Access Compliance Report

Public Rights-of-Way

(Curb Ramps)

Intersection ID: 17196	Main Street: IDLEWILD_RD	Cross Street: CONFERENCE_DR	Location: SW
ADA ID: 7FD1A32BDA62	Ramp Type: Perp	Initial Pass/Fail: Fail	Overall Compliance: No
			Severity Score: 33.75

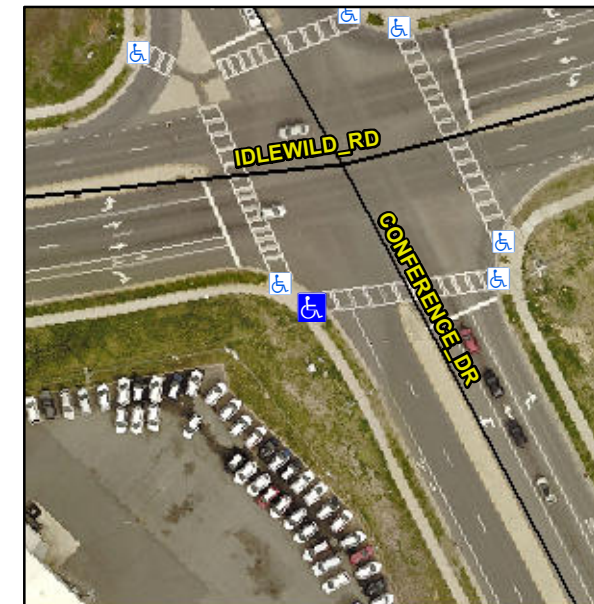
Not Found, R304.5.1, R304.2.2, R304.5.3

Compliance	Description	Data	Compliance	Description	Data
N/A	Ramp Length (in)	67.0	No	Ramp Slope (%)	9.8
No	Ramp Width (in)	47.0	No	Ramp XSlope (%)	5.5
N/A	Flare Type LT	N/A	N/A	Flare Type RT	N/A
N/A	Flare Slope LT (%)	N/A	N/A	Flare Slope RT (%)	N/A
N/A	Flare Traversable LT?	N/A	N/A	Flare Traversable RT?	N/A
N/A	Landing Length (in)	N/A	N/A	DWS Provided?	N/A
N/A	Landing Width (in)	N/A	N/A	DWS Contrast?	N/A
N/A	Landing Slope (%)	N/A	N/A	DWS Length (in)	N/A
N/A	Landing X Slope (%)	N/A	N/A	DWS Full Width?	N/A
N/A	Landing Curb? (Y/N)	N/A	N/A	DWS Offset (in)	N/A
N/A	Shared Landing?	N/A			
N/A	Gutter Ponding?	N/A	N/A	Gutter Slope (%)	N/A
N/A	Gutter Lip Ht (in)	N/A	N/A	Gutter X Slope (%)	N/A
N/A	Painted X Walk1?	Yes	N/A	Painted X Walk2?	N/A
	X Walk 1 Direction	To E		X Walk 2 Direction	N/A
N/A	X Walk 1 Width (in)	111.0	N/A	X Walk 2 Width (in)	N/A
	X Walk 1 Slope (%)	1.0		X Walk 2 Slope (%)	N/A
	X Walk 1 X Slope (%)	4.8		X Walk 2 X Slope (%)	N/A

Remove & Replace Entire Ramp.
